Re: Comments on PSC Case 10-E-0155, Proceeding on Motion of the Commission as to New York State's Electric Utility Transmission Right-of-Way Practices

Tree heights conforming to distance requirement to avoid arcing for 242 kV lines.

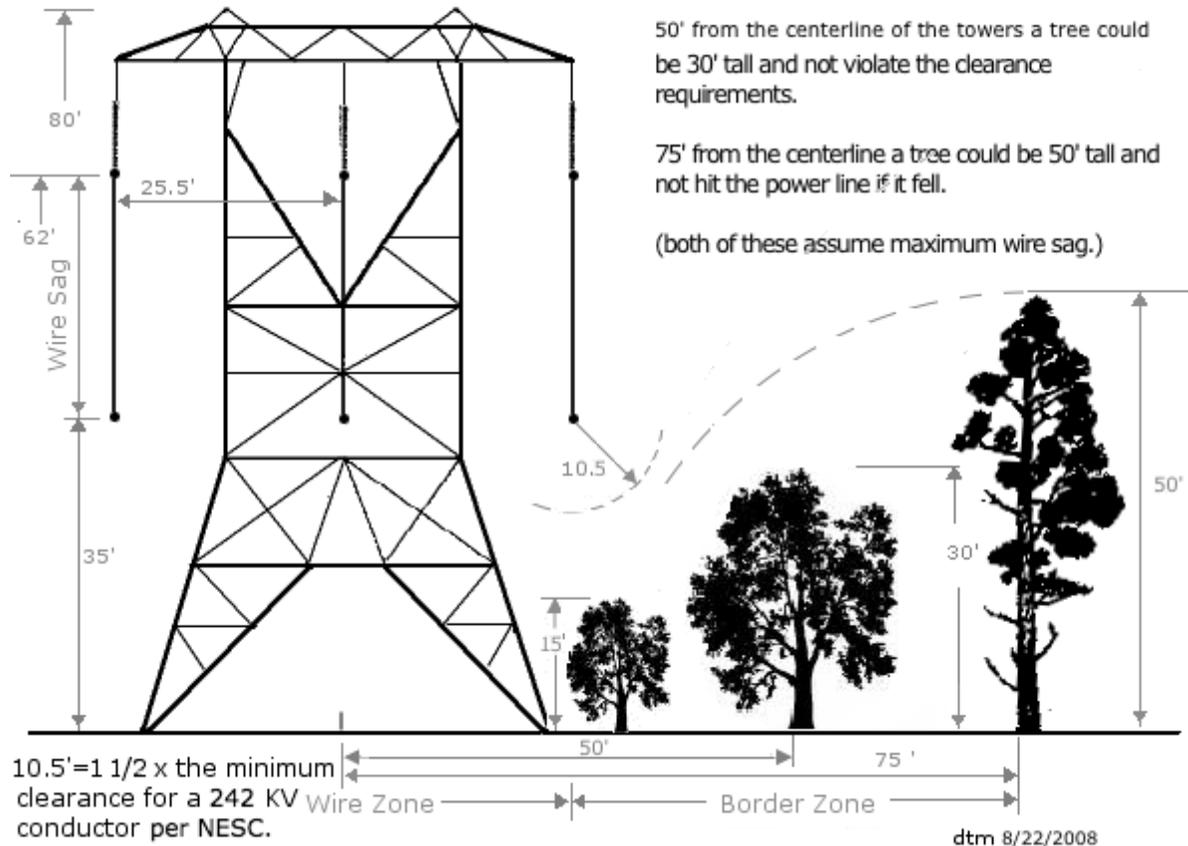
Rather than removing all trees within the ROW wire *and* border zones, a tiered management approach, based on the Federal NERC FAC-003 guidelines, allows for increased tree height as distance from the wire zone increases, without violating the clearance requirements.³

As illustrated above, a 50-foot-tall tree at the outer edge of the ROW border zone does not present a hazard should it fall toward the wire at its lowest sag point. Likewise, trees that are successively tiered at lower heights closer to the wire zone present no line hazard. For these reasons, the clear-cutting of all trees within the ROW border zone is entirely unnecessary, in addition to the environmental impacts associated with such practices.
